Bedroom 1's bathroom · design review F-05 · accept the route (A) or a private bathroom (B)? · Taif / Palm House V8.1 · STUDY ONLY

OPTION A ADOPTED by the owner (2 Nov 2026): no private bathroom; the wet areas stay grouped in the two clusters; night lights along the route. 2 Nov 2026, after the stair flip (option B, F-b) · bedroom 1 is the north-east room over the maid wing, 15.75 m² on axes, 13.9 m² clear, one room without a bath · nothing in the design files changes until the owner decides · all sizes assumed

bedroom 1 · A · 1 m = 0.95 cm · north up · brown dotted = the ground floor below

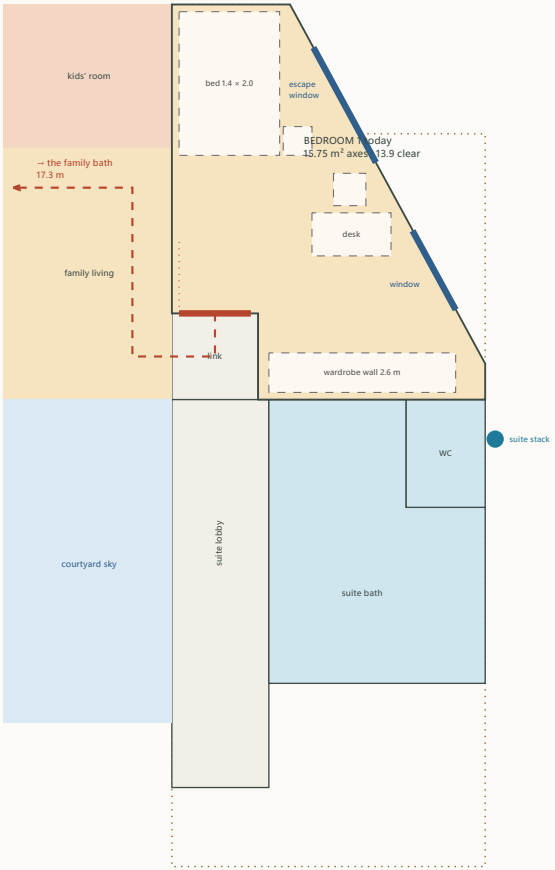
- **The walk, measured after Part 1** (the stair flipped, the family bath enlarged northwards; its door stays at x 4.25, y 9.3–10.3): bedroom 1's door → the family link → the family living, behind the sofa → the gallery's north part, past the stair arrival → the gallery → the bath's door: **17.3 m** (the same as before the flip: the bath grew, its door did not move). Five spaces, two of them lived in (the living, the gallery).

- **Who shares the family bath:** bedroom 1 (17.3 m), bedroom 2 (2.7 m), the kids' room and the family living (a bedroom later); bedroom 3 and the suite have their own. Since F-b it has **two compartments** (a WC by the shaft and the shower + double basin), so two children at once.

- **Comfort:** a child or a guest in bedroom 1 crosses the **family living** at night and in the morning, in sight of whoever is there; 17 m is the longest bathroom walk in the house (the suite's is 0, bedroom 3's 2.7, bedroom 2's 2.7).

- **Cost:** nothing; the plumbing stays as it is.

bedroom 1 · B2 · 1 m = 0.95 cm · north up · brown dotted = the ground floor below

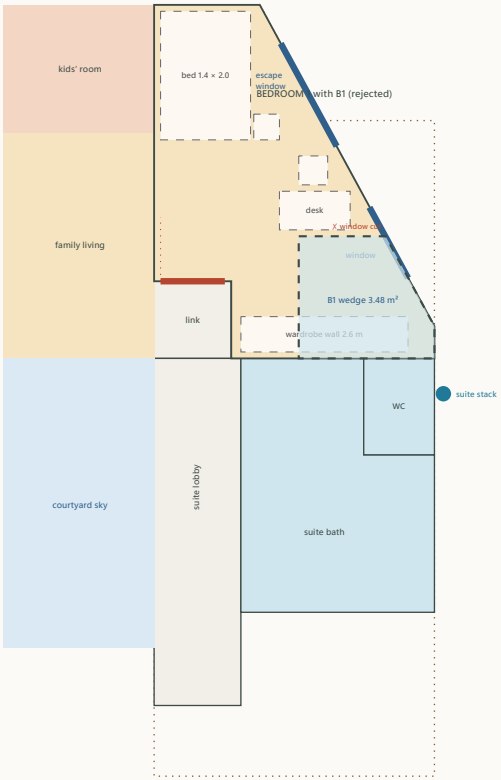
- **B2 (the best, drawn):** a bath along bedroom 1's **south wall**, x 10.6–13.311, y 5.0–6.5, its east end following the cut wall: **3.79 m² on axes, 2.49 × 1.3 clear less the slant ≈ 3.0 m²**: a walk-in shower 0.9 × 1.2 at the east end (its corner 0.02 m west of the cut wall), the WC in the middle facing north, the basin on the west wall, a **sliding 1.0 m door** from the room (no swing), a **small window on the cut wall** (y 5.35–5.85, sill +1.60, obscured). It is **next to the master suite's wet stack**: the pipes run 2.5 m east in the bath's own floor zone to the suite's stack outside the east wall (y 7.05), **over the GF maid room only** (the kitchen and its hood zone start at y 7.0; nothing over the master bedroom).

- **Bedroom 1 with B2: 11.96 m² on axes, ≈ 10.3 m² clear** (was 15.75 / 13.9): the bed 1.4 × 2.0 stays on the west wall with its bedside table, the desk and chair under the escape window, the wardrobe wall (2.6 m) becomes **two wardrobes, 1.3 m on the bath's wall and 0.9 m on the west wall** (2.2 m in all); the door's swing stays clear; the **escape window stays the room's** (the fire study unchanged); the second window (y 4.15–5.25) lights the desk. Still a full bedroom (a 1.4 bed, a desk, 2.2 m of wardrobe), no longer a two-bed room.

- **Drain:** the shower, the WC and the basin to one branch running east along the bath's south side to the **suite's stack** outside the east wall (y 7.05), 2.5 m; the branch crosses the room's south wall line at x 13.311 and turns south outside the wall for 0.6 m (or a second stack beside the suite's; the MEP engineer). **Over the GF maid room only**: not over the kitchen (y ≥ 7.0), its hood zone (the east wall y 10.2–11.2) or the master bedroom (x 8.95–13.311, y 11.9–19.25).

- **Structure (`studies/structure.typ`):** the maid wing's first-floor bay is a **solid 0.20 slab** spanning east–west 4.36 m to the cut wall; a 0.15 depressed zone cannot be cut from 0.20. Two ways, the engineer's choice: **(i)** cast the bay 0.35 thick under the bath with its top depressed 0.15 (as the suite bath, X10), or **(ii)** keep the slab and run the pipes **below** it in the maid room's ceiling void (the maid room gets a gypsum ceiling anyway; 3.1 m clear left) with a wall-hung WC and a shower tray raised ≈ 0.10. The bath's walls are light partitions on the slab (no beam; B6 at y 6.5 is the room's south wall beam, untouched).

- **Windows:** the bath's small window on the cut wall faces the lane side (obscured glass, a vent); the room keeps both its windows. **Ventilation:** the window plus an extract fan to the roof riser is not available here: an extract through the cut wall (a small louvre) or a duct in the ceiling void to the east wall.

- **Neighbours:** the maid room below hears the bath (pipes in a ceiling void: wrap them); the suite's WC closet shares the stack; the family link and the suite lobby are untouched; the family bath keeps serving bedroom 2, the kids' room and the living.

Recommendation: B2, if bedroom 1 is to be a guest room or an older child's room; otherwise A

- The route is the longest in the house and crosses the living: that is the real cost of A, and the only one. B2 answers it for ≈ 3 m² of the room and one more wet room; it is the only tidy position (B1 is a wedge that cuts a window, B3 takes the escape window). **Conditions for B2:** the engineer chooses the slab detail (i) or (ii); the MEP engineer the stack connection and the vent; the wardrobe split accepted.
- **If A:** keep the family bath as F-b (two compartments) and note in the house rules that bedroom 1's user has the family bath; nothing else to do.
